Discussion of Modifications to 802.1AS-2020 to Resolve Maintenance Items 369, 371, and 372

IEEE 802.1 Maintenance TG
2024.09.10

Introduction

Figure 12-7. TimeReceiver state machine

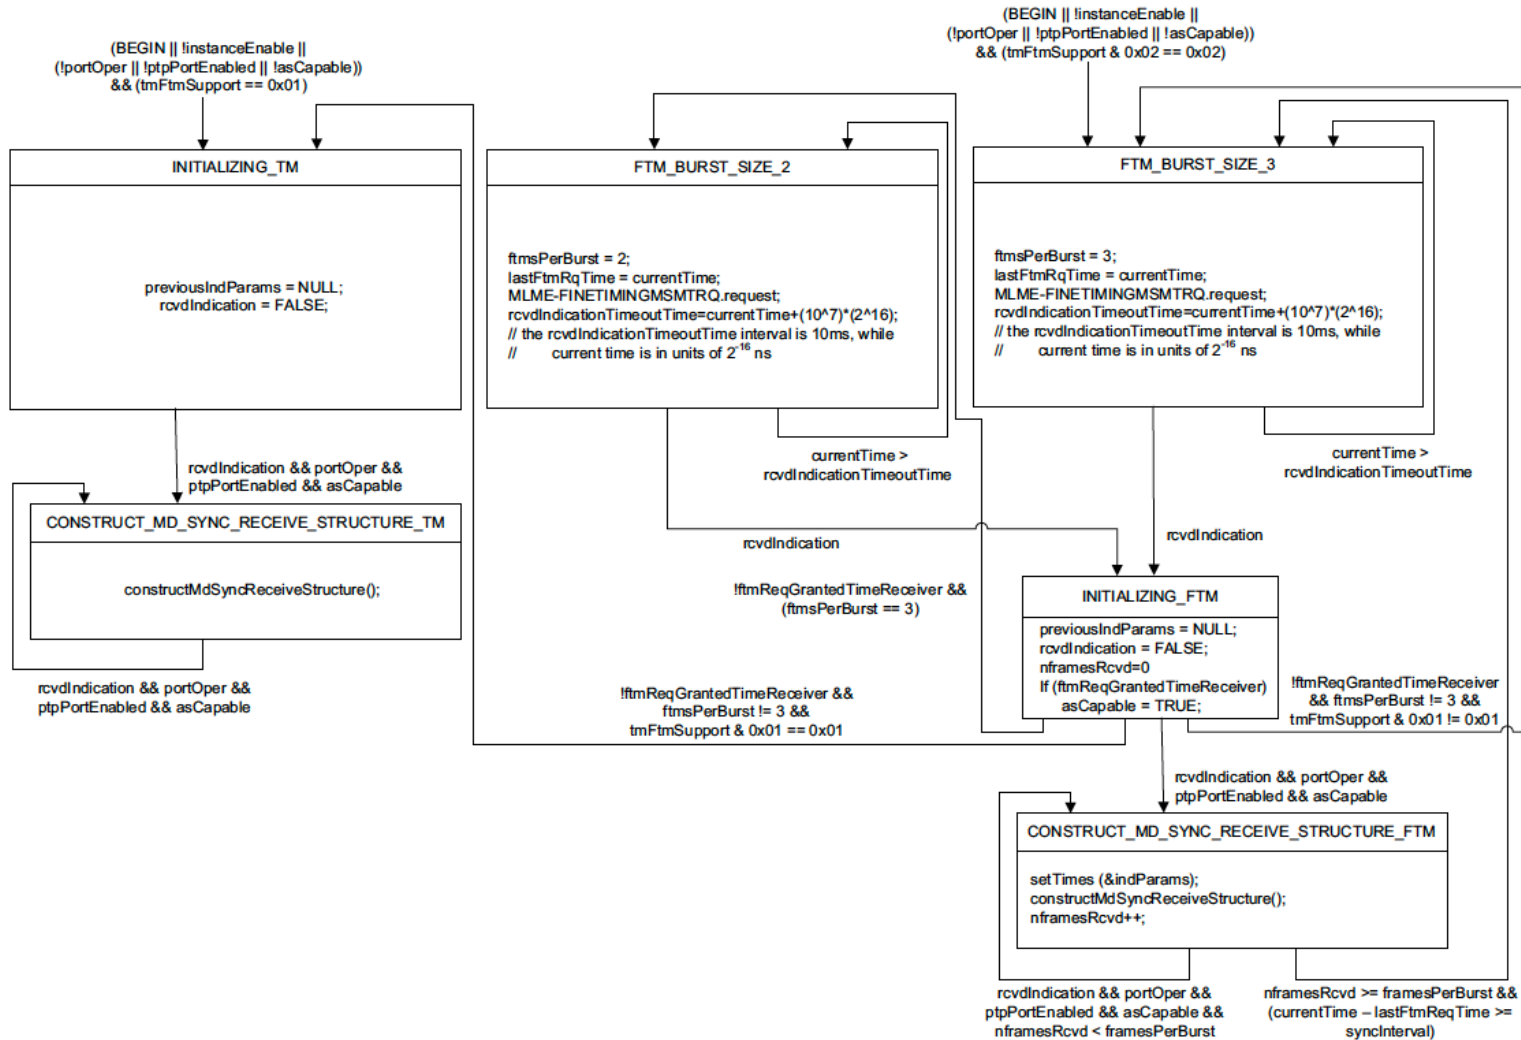
There is a mix of names in the slave state machine (Fig. 12-7) . It seems that "ftmsPerBurst" and "framesPerBursts" is used for the same variable.

In Fig. 12-7 change "framesPerBursts" to "ftmsPerBurst".

- The CONSTRUCT_MD_SYNC_RECEIVE_STRUCTURE_FTM state has the code:

- In addition, the transition out of this state to the initial state for the FTM case, i.e., FTM_BURST_SIZE_3 state, has the condition:

- ❑ But, the first else if block of the function `constructMdSyncReceiveStructure()`; has the statements

- ❑ The second and third statements are not needed, as their functionality is contained in the `CONSTRUCT_MD_SYNC_RECEIVE_STRUCTURE_FTM` state

- Note that the variable `RESTART` is not set and is not used anywhere else
- Inspection of earlier drafts of 802.1AS-2020 indicates that this had been used in the earlier drafts; however, the variable was subsequently eliminated and the `TimeReceiver` state machine was revised
- The second and third statements of the first else if block of `constructMdSyncReceiveStructure()`; should have been deleted when the state machine was revised

- ❑ As indicated in the maintenance item rationale for revision, both `framesPerBurst` and `ftmsPerBurst` are used in Figure 12-7
- ❑ `ftmsPerBurst` is defined in 12.5.2.3.8 as a local variable for the media-dependent `TimeReceiver` state machine:

- ❑ `framesPerBurst` is not explicitly defined; however, it is used in the following places:
 - Figure 12-7, in conditions for transitions leading out of the `CONSTRUCT_MD_SYNC_STRUCTURE_FTM` state
 - A parameter of the `initReqParamsDot11TimeTransmitter` structure
 - A parameter of the `initReqParamsDot11TimeReceiver` structure

- ❑ In the normal case, where the request is granted, this is the same as `ftmsPerBurst` of 12.5.2.3.8 of 802.1AS-2020, and was intended by the stand-alone local variable “`framesPerBurst`” in Figure 12-7
- ❑ Based on this discussion, the stand-alone local variable “`framesPerBurst`” in Figure 12-7 should be changed to “`ftmsPerBurst`”
- ❑ In addition, for consistency the nomenclature used in 802.11-2020, the instances where “`framesPerBurst`” is used as the name of members of the `initReqParamsDot11TimeTransmitter` and `initReqParamsDot11TimeReceiver` structures can be changed to “`ftmsPerBurst`”

□ Resolution of Maintenance Item 369:

- Delete the statements:

```
MLME-FINETIMINGMSMT.indication(&indParams);
```

```
nframesRcvd++;
```

```
if (nframesRcvd == initReqParamsDot11SlaveTimeReceiver.framesPerBurst) ||  
    (currentTime > endofBurstDurationTime)  
    RESTART=1;
```

from the function constructMdSyncReceiveStructure(); (of 12.5.2.4.4)

□ Delete 12.5.2.3.4 (definition of the variable RESTART)

□ Therefore, maintenance item 371 can be resolved as follows:

- Change “framesPerBurst” to “ftmsPerBurst” in the conditions exiting the CONSTRUCT_MD_SYNC_STRUCTURE_FTM state of Figure 12-7
- Change “framesPerBurst” to “ftmsPerBurst” in the following places:
 - Figure 12-6 (2 places, where it is a member of the structure initReqParamsDot11TimeTransmitterB)
 - 12.5.1.4.5, fourth line of the function initRequestWaitConfirm(), where it is a member of the structure initReqParamsDot11TimeTransmitterB
 - 12.5.2.4.4, ninth line of the function constructMdSyncReceiveStructure(), where it is a member of the structure initReqParamsDot11TimeReceiver

Figure 12-2—Fine Timing Measurement procedure for IEEE 802.11 links

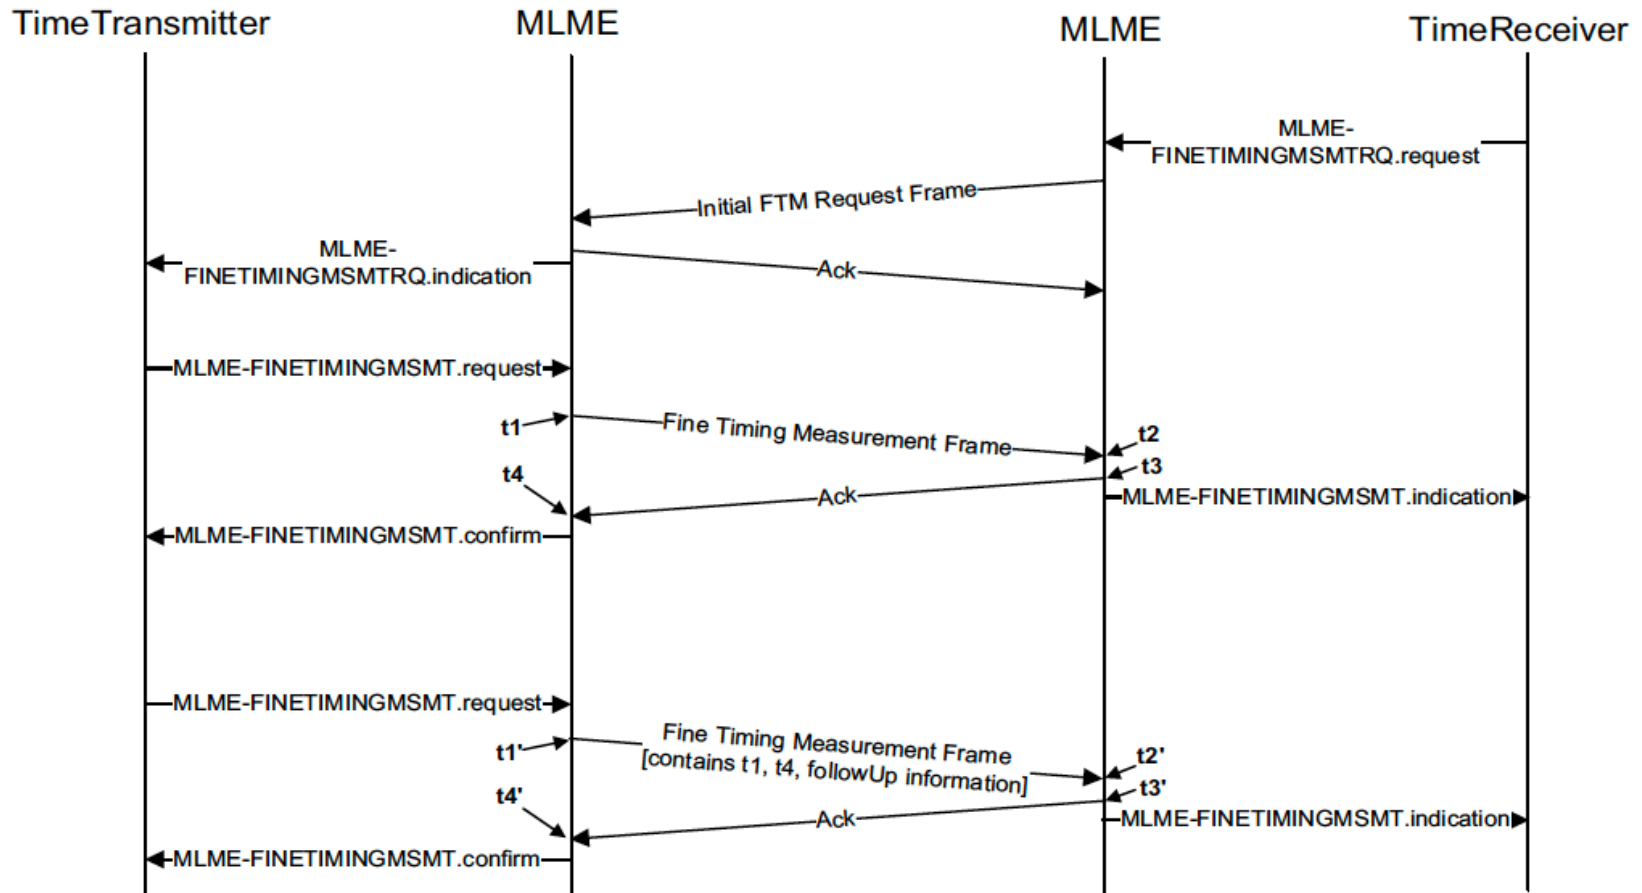
- ❑ It is convenient to discuss maintenance item 372 prior to discussing item 371
- ❑ Subclause 12.5.2.3.7 states:
 - **12.5.2.3.7 initReqParamsDot11Slave:** A structure whose members contain the values of the fields of an MLME-FINETIMINGMSMTRQ.indication primitive.
- ❑ Figure 12-2, copied on the next slide, shows the FTM procedure
- ❑ It is clear from this figure that TimeReceiver issues the MLME-FINETIMINGMSMTRQ.request primitive, and not the MLME-FINETIMINGMSMTRQ.indication primitive
 - The MLME-FINETIMINGMSMTRQ.indication primitive is issued by the MLME to the TimeTransmitter
- ❑ Therefore, this maintenance item can be resolved by accepting the proposed text, i.e.,

Proposed text:

Change paragraph to: "A structure whose members contain the values of the fields of an MLME-FINETIMINGMSMTRQ.request primitive."
